Access Compliance Report Public Rights-of-Way (Curb Ramps)

Main Street: REGAL_AVE Cross Street: MAC_ST Location: SE

ADA ID: RPRK210921143836 Ramp Type: Type 1 - Perpendicular Diagonal Initial Pass/Fail: Fail Overall Compliance: No Severity Score: 2

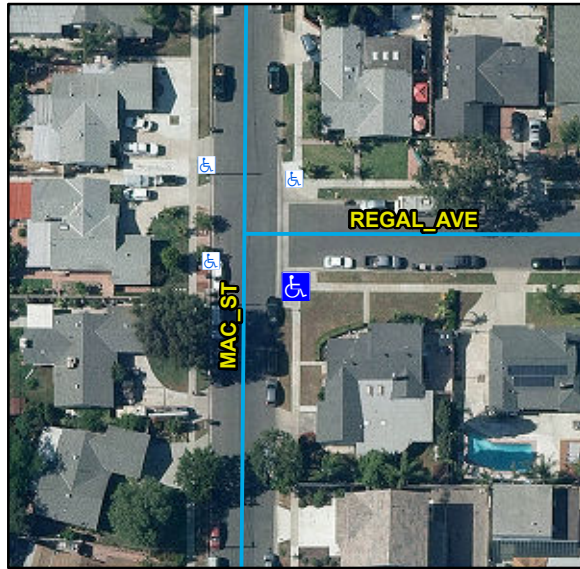
Compliance	Description	Data	Compliance	Description	Data
N/A	Ramp Length (in)	59	N/A	Flare Type LT	
Yes	Ramp Width (in)	48			N/A
Yes	Ramp Run Slope (%)	5.5	N/A	Flare Slope LT (%)	N/A
No	Ramp Cross Slope (%)	4.7	N/A	Flare Traversable LT	N/A
N/A	Landing Present	N/A	N/A	Flare Type RT	
N/A	Landing Length (in)	N/A			N/A
N/A	Landing Width (in)	N/A	N/A	Flare Slope RT (%)	N/A
N/A	Landing Run Slope (%)	N/A	N/A	Flare Traversable RT	N/A
N/A	Landing Cross Slope (%)	N/A	N/A	DWS Provided	N/A
N/A	Landing Movement Obstructed?	N/A	N/A	DWS Contrast	N/A
	Landing Movement Type	N/A	N/A	DWS Length (in)	N/A
N/A	Landing Shared	N/A	N/A	DWS Full Width	N/A
N/A	Clear Space	Yes	N/A	DWS Offset Left (in)	N/A
N/A	Clear Space To Crosswalk (in)	N/A	N/A	DWS Offset Right (in)	N/A
N/A	Marked Crosswalk 1	No	N/A	Marked Crosswalk 2	No
	Crossing 1 Direction	N		Crossing 2 Direction	W
	Marked Crosswalk 1 Width (in)	N/A		Marked Crosswalk 2 Width (in)	N/A

Remove & Replace Curb Ramp With Two New Directional Ramps or Equivalent.

R304.5.3, STD 1115
